## PLANNING TECHNICAL REVIEW COMMITTEE –AGENDA

## PLAN SNAPSHOT REPORT WAIV-2023-0006 FOR CITY OF DOVER, N.H.

**RE: Second Street Courthouse – Site Plan Amendment  
10 Second Street  
Dover Planning File: P21-30**

**TO:** Donna Benton, Planner, City of Dover      **DATE:** 6/8/2023  
**FROM:** Neil J. Rapoza, PE  
CIVIL CONSULTANTS  
**SUBJECT:** Plan Revision Memo  
**PROJECT:** 20-279.00 One First Street, LLC (Dover project #P21-30)

A0

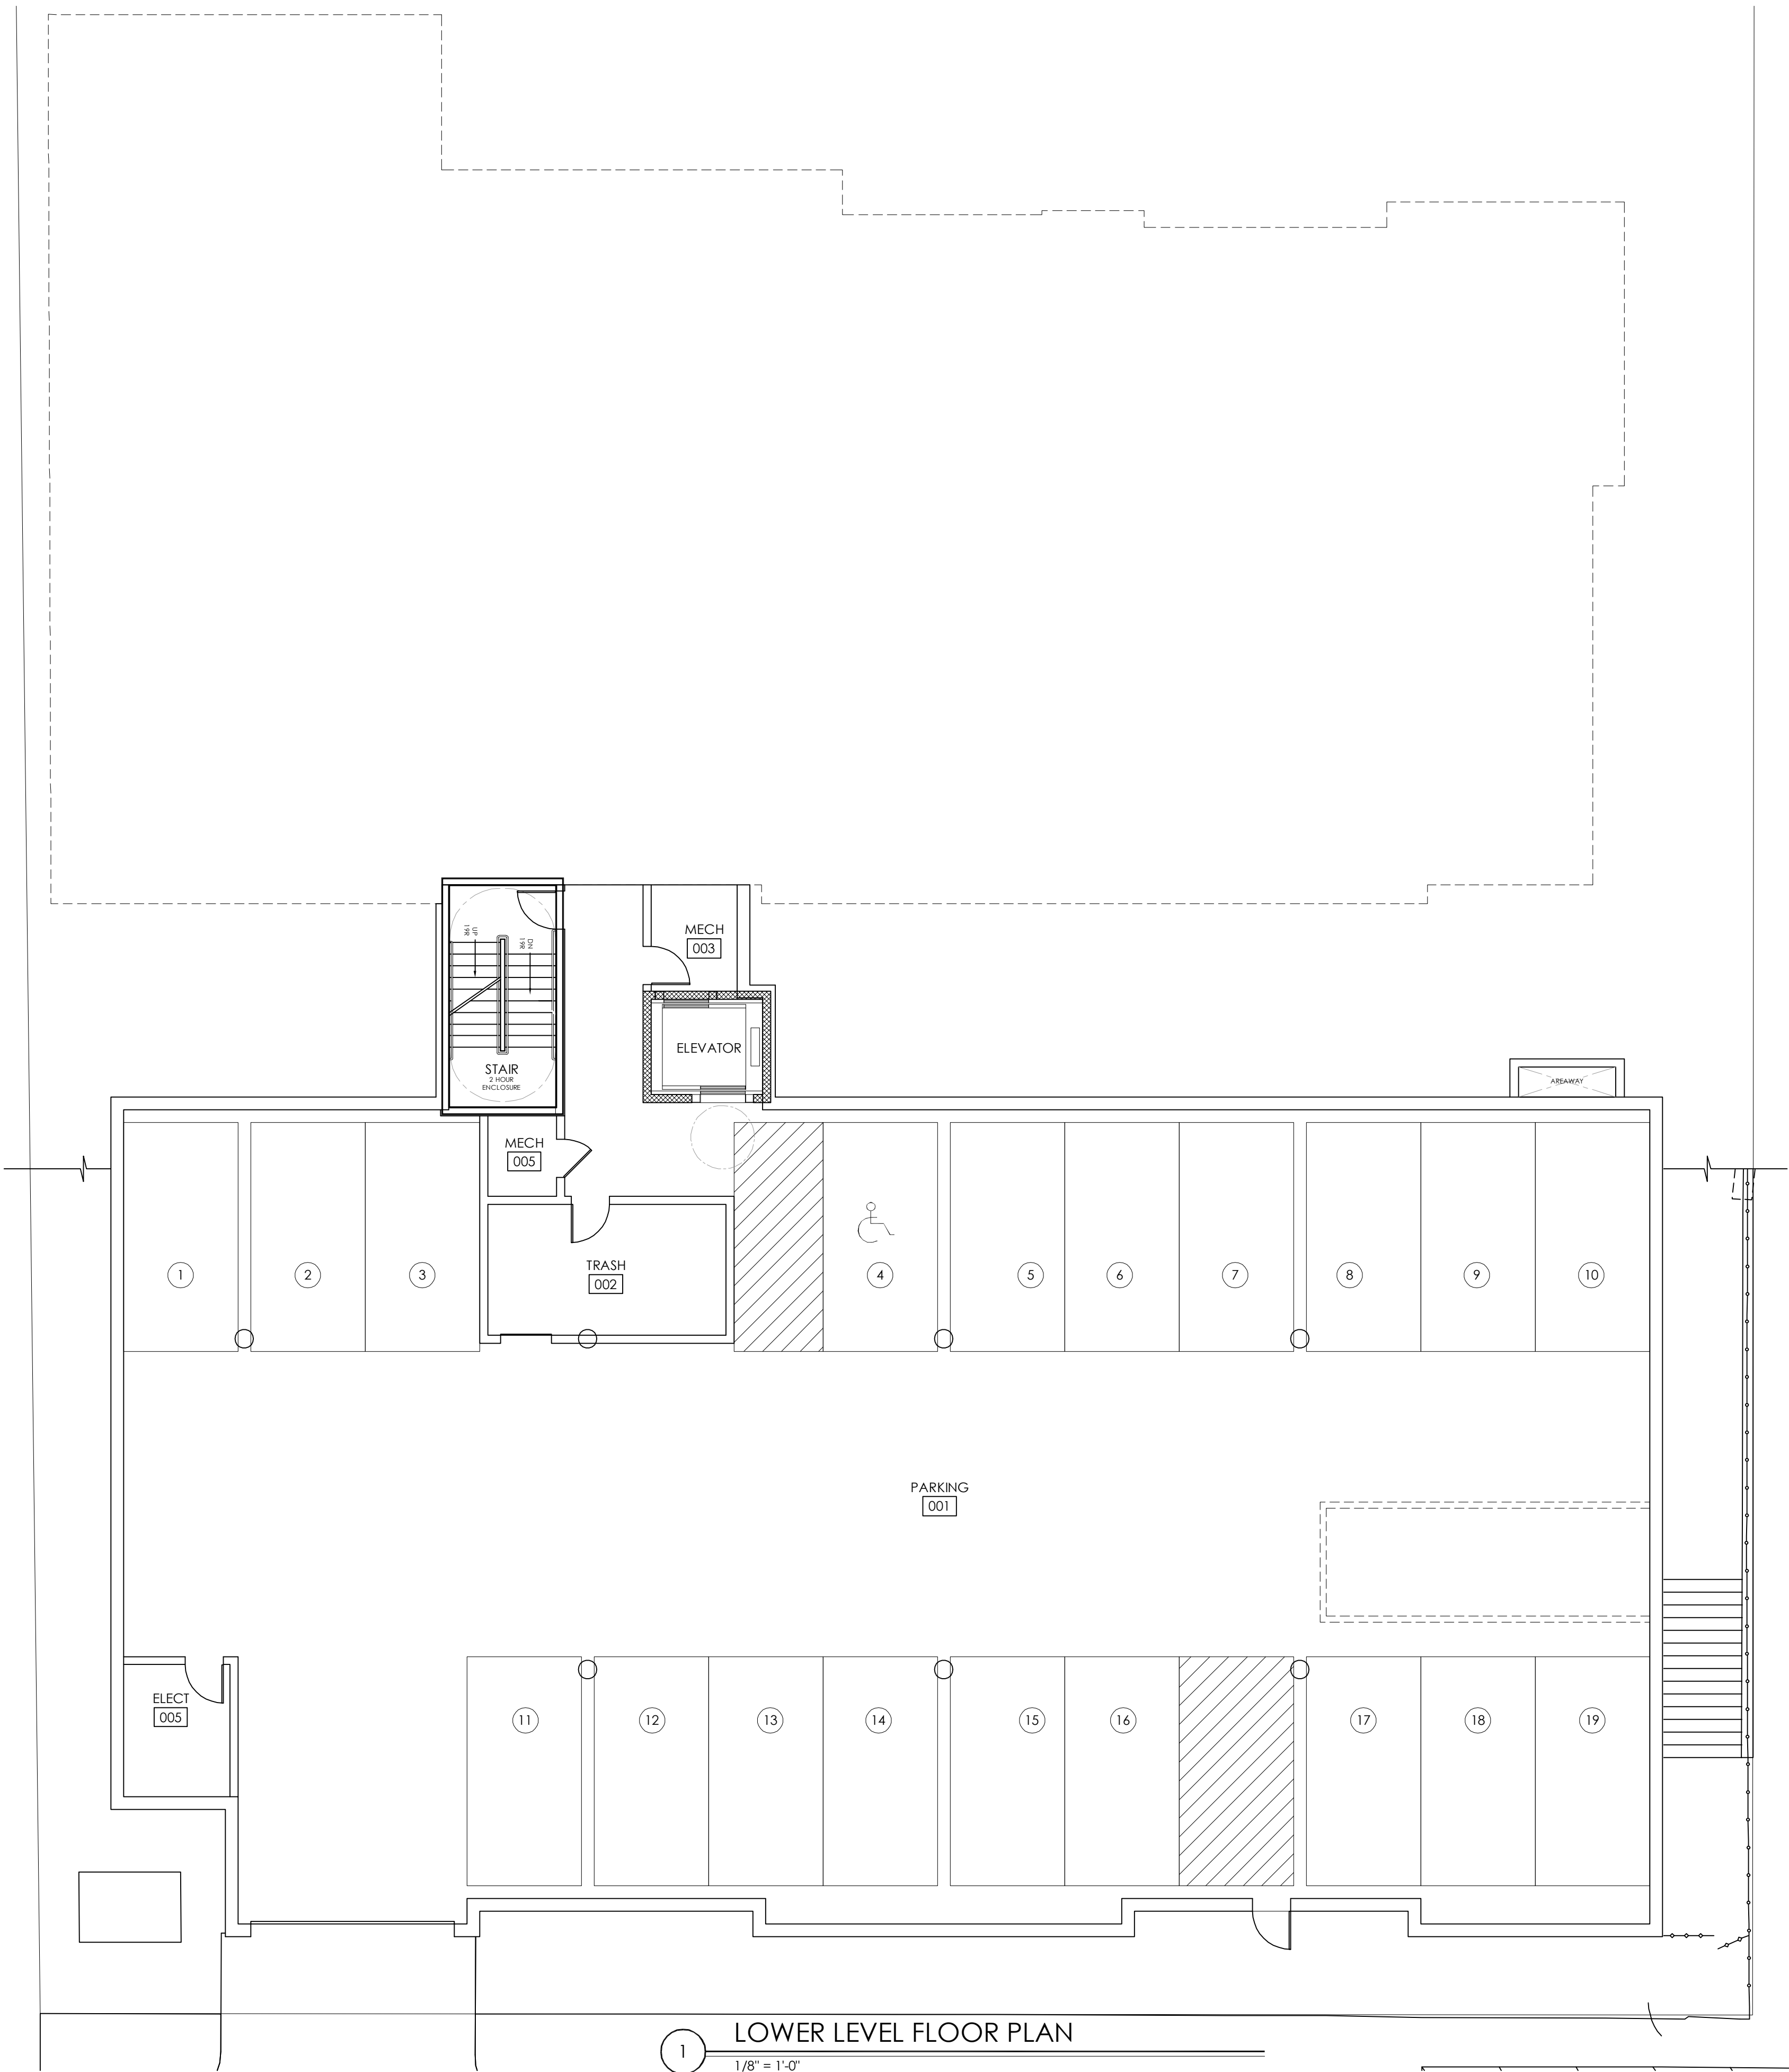
### Sheet A0

- a. Second Street isometric view revised to indicate modified site plan and commercial patio area.
- b. Building modified to indicate new entry to commercial space and revised canopy to main entrance.
